RE: **Lot 7 Block 7 S.A.D. 227 Unit 2**
7911 Kibo Dr. NW
Grading and Drainage Plan
Engineers Stamp Date 3/12/20 (E10D060)

DRAINAGE AND TRANSPORTATION INFORMATION SHEET (REV 6/2018)

Project Title: 7911 KIBO **Building Permit #:** _____ **Hydrology File #:** E10D060
DRB#: _____ **EPC#:** _____ **Work Order#:** _____
Legal Description: LOT 7 , BLOCK 7 VOLCANO CLIFFS UNIT 2
City Address: 7911 KIBO

ENGINEER'S SEAL DAVID SOULE REGISTERED PROFESSIONAL ENGINEER 14522 3/12/20 DAVID SOULE P.E. #14522	7911 KIBO	DRAWN BY: WCUJ
	GRADING AND DRAINAGE PLAN	DATE: 3-12-20
	 1606 CENTRAL AVENUE SE SUITE 201 ALBUQUERQUE, NM 87106 (505) 872-0998	2109027-LAYOUT-3-28-19 SHEET # — JOB # 2109027

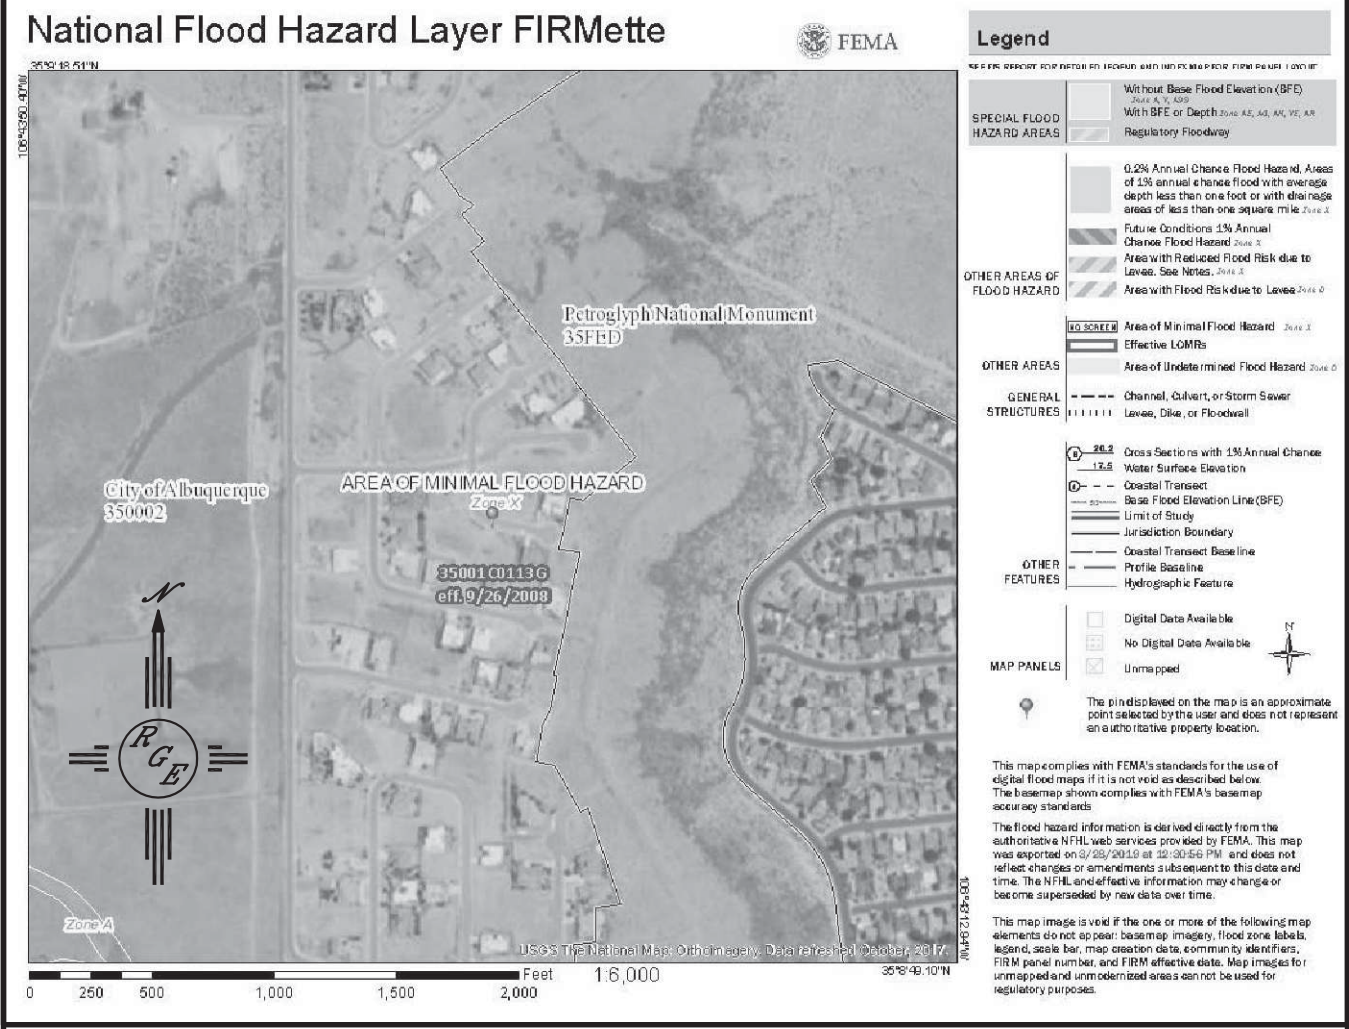
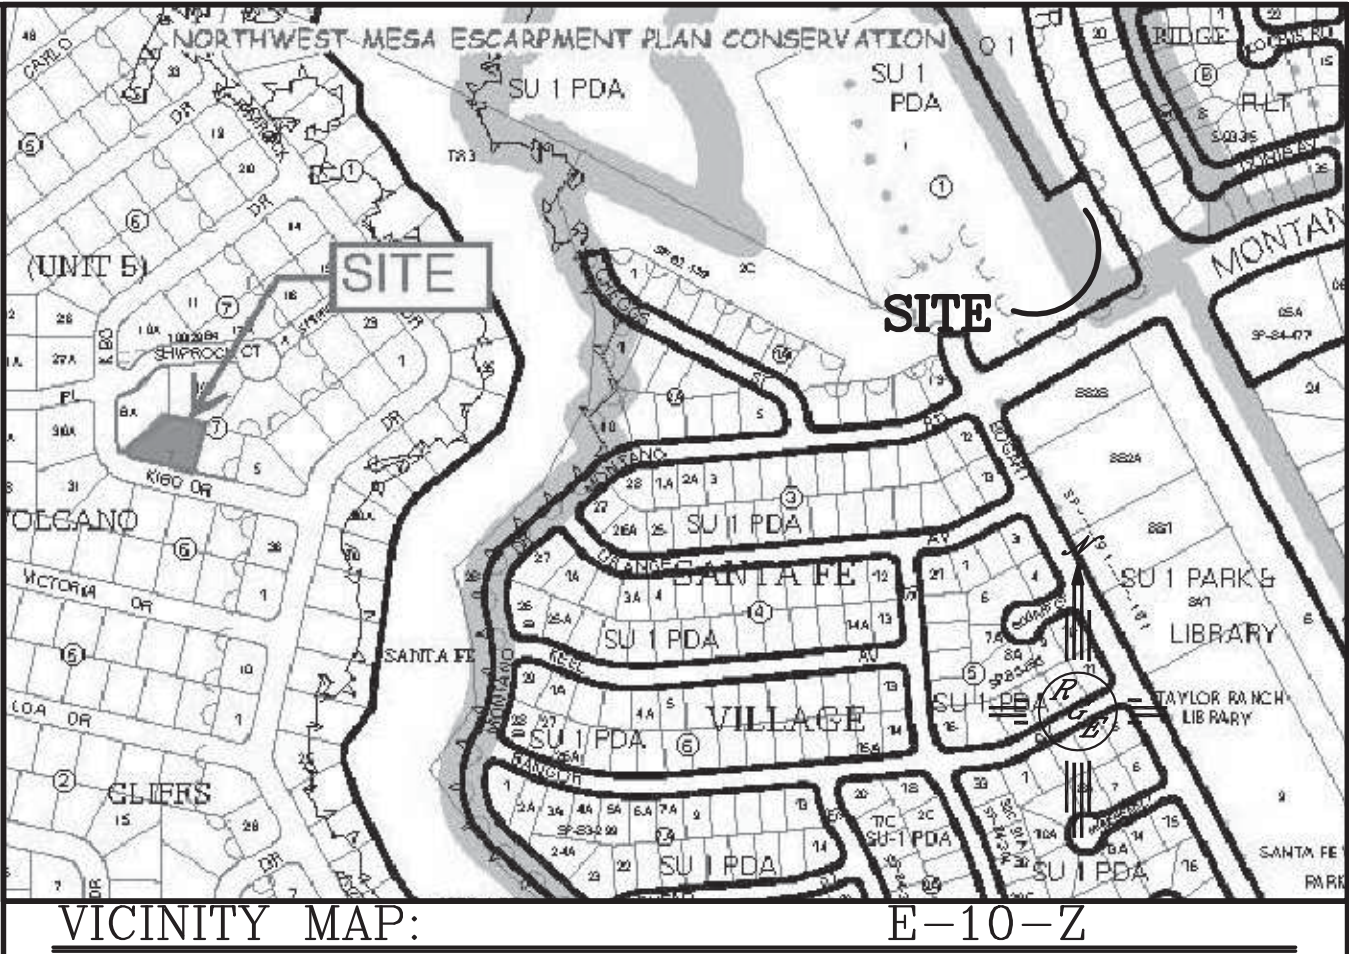
Based upon the information provided in your submittal received 3/16/20, this plan is approved for Grading Permit. Please inform the builder/owner to attach a copy of this approved plan and letter into the construction sets in the permitting process prior to sign-off by Hydrology.

Reiterate to the Owner/Contractor that a separate permit for any garden/retaining wall must be obtained, with the approved G&D plan.

Prior to Building Permit approval, a **Pad Certification** will be required. Inform the contractor/owner not to pile dirt in the street as a ramp to climb the curb. If dirt is found in the street the pad cert. will be denied.

Prior to **Certificate of Occupancy release**, Engineer Certification per the DPM checklist of this plan will be required.
